<b>BRIEF DESCRIPTION OF REQUEST</b>
Final sign-off for Site Development Plan for Building Permit approved by EPC on June 14, 2018

**Project# 1003449**  
18EPC-40031 Sector Development Plan Map Amendment  
18EPC-40032 Site Development Plan for Building Permit

**RE: Sunset Gardens – Project #1003449; Site Development Plan for Building Permit Final Sign Off 18EPC-40032**

**SUNSET GARDENS APARTMENTS PROPOSED NAME OF PLAT AND/OR SITE DEVELOPMENT PLAN**

ENGINEER'S R. G. GARDNER 5-28-18
	86TH AND SUNSET GARDENS MASTER UTILITY PLAN
SHEET # 4A	DRAWN BY DATE 5-20-18

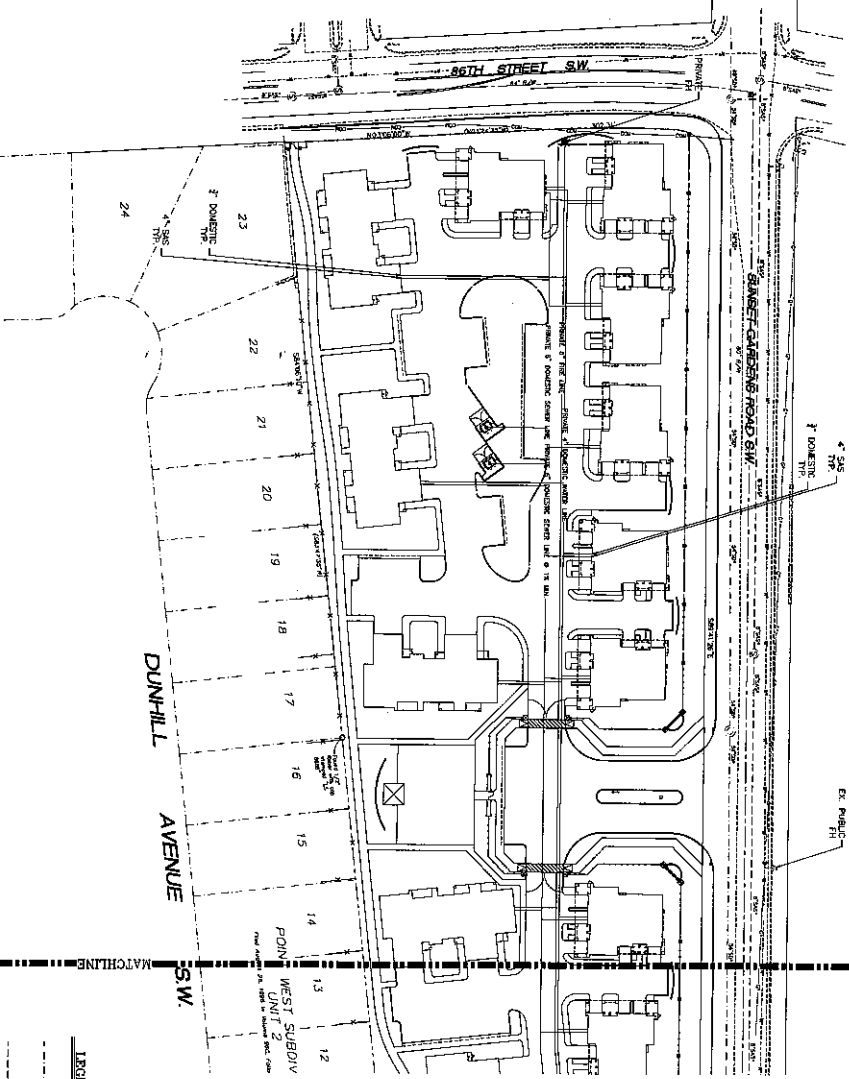
- d. The proposed utility plan indicates several onsite fire hydrants. These hydrants are to be considered private and painted safety orange.
  - e. The proposed utility plan indicates installation of a new manhole approximately 80 feet upstream of an existing manhole. If contributions to the public sanitary sewer infrastructure require the development to discharge to a manhole the development shall connect to the existing manhole downstream of the proposed. If this connection is unacceptable coordination with Utility Development shall take place to evaluate the proposed connection further.

*Agreed. Our team submitted for the Availability Statement. See the attached City Fire Marshal approved Fire I Plan. See Site Plan note #28 and Utility Plan regarding water meter.*

DOUBLE TRASH ENCLOSURE PLAN

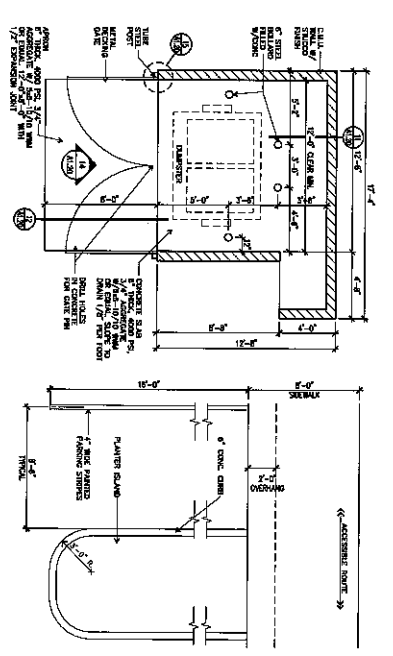
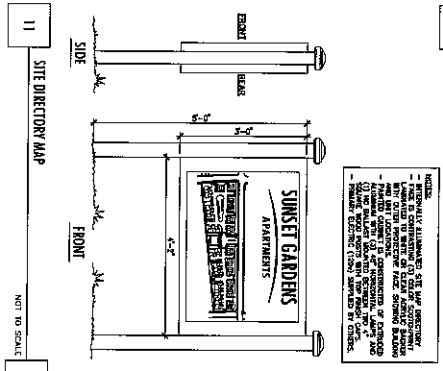
3. Pursuant to Comprehensive Plan Policy 9.2.1, the trash enclosure shall be moved north, away from the southern property line as far as practicable and as is acceptable to the Solid Waste Department. Additional landscape buffering between the dumpster location and the residential properties to the south shall also be provided.

*Agreed, we removed four parking spaces north of the trash enclosure to move the enclosure away from the southern property line. Additional landscape buffering was added between the enclosure and the southern property line to include three Austrian pine, four blue butterfly bush, three gold scotch broom, one dynamite crape myrtle, and one Hall’s honeysuckle. The change in location of the trash*

*enclosure was approved by the Solid Waste Department, see attached signed Site Plan.*

*Agreed, the west side enclosure was set farther East and re-angled to improve the refuse truck access. The Solid Waste Department reviewed and approved this change. See attached signature.*
